[Docket No. FAA-2013-0019; Directorate Identifier 2010-SW-051-AD; Amendment 39-17485; AD 2013-12-07]

Airworthiness Directives; Bell Helicopter Textron Canada Helicopters

ACTION: Final rule.

Figure 1 to Paragraph (e)

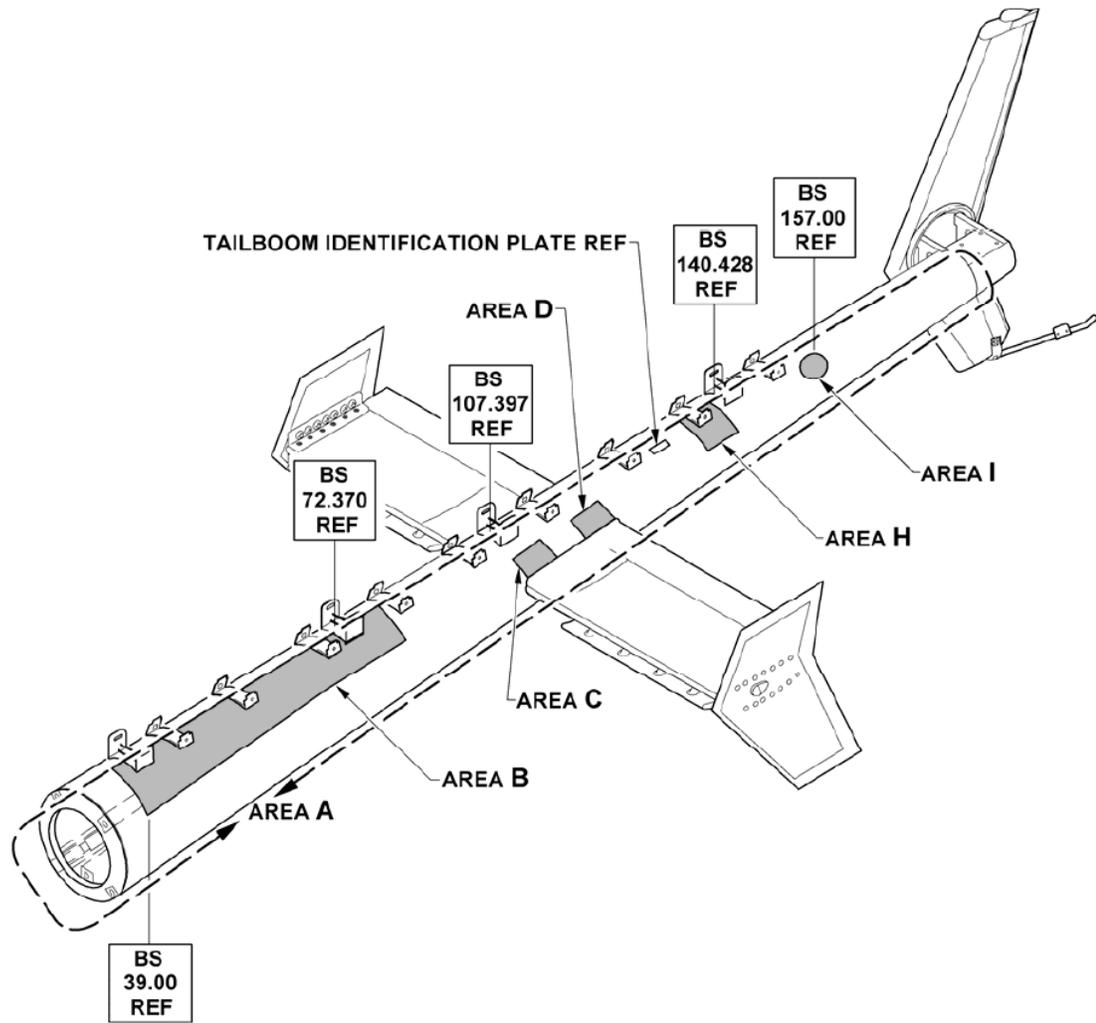
(A) Before the first flight of each day, visually check for a crack in the “C” and “D” areas depicted in Figures 1 and 2 to Paragraph (e) of this AD. The actions required by this paragraph may be performed by the owner/operator (pilot) holding at least a private pilot certificate, and must be entered into the aircraft records showing compliance with this AD in accordance with 14 CFR §§ 43.9 (a)(1)-(4) and 14 CFR § 91.417(a)(2)(v). The record must be maintained as required by 14 CFR §§ 91.417, 121.380, or 135.439; or

Figure 2 to Paragraph (e)

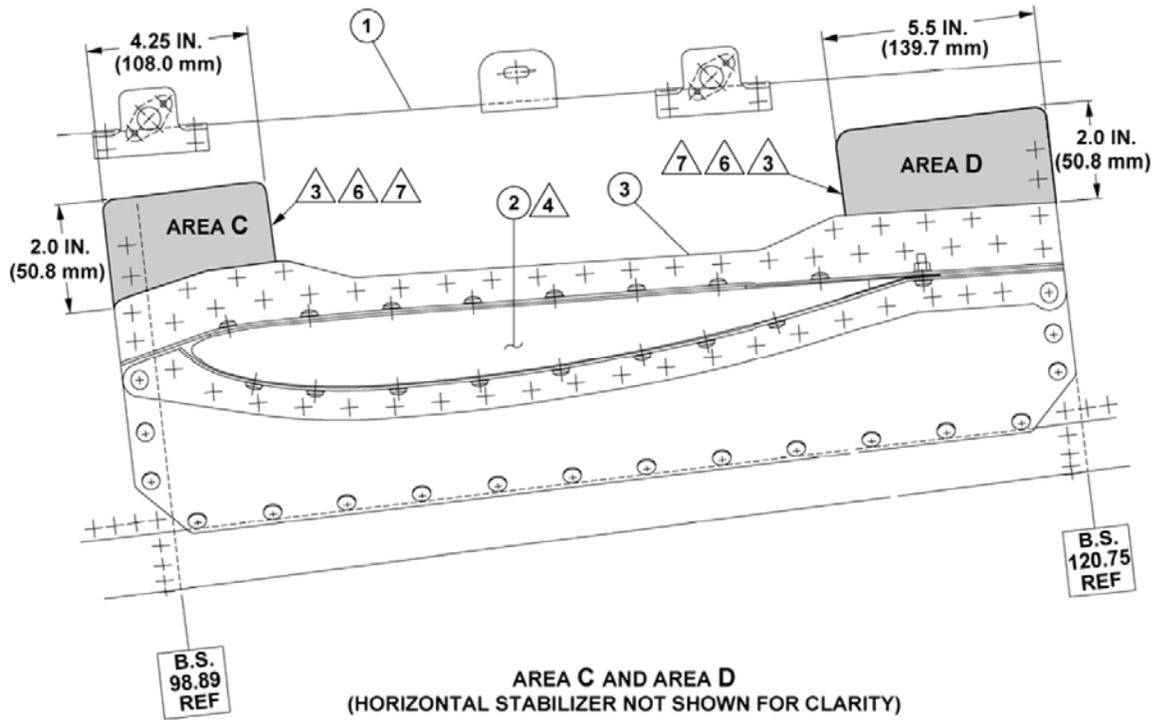
(B) Within 25 hours TIS, or 30 days, whichever comes first, and thereafter at intervals not to exceed 50 hours TIS, clean and inspect for a crack around each fastener and just above the edge of the upper stabilizer support in the “C” and “D” areas on the left side of the tailboom assembly, as depicted in Figure 2 to Paragraph (e) of this AD, using a 10X or higher power magnifying glass.
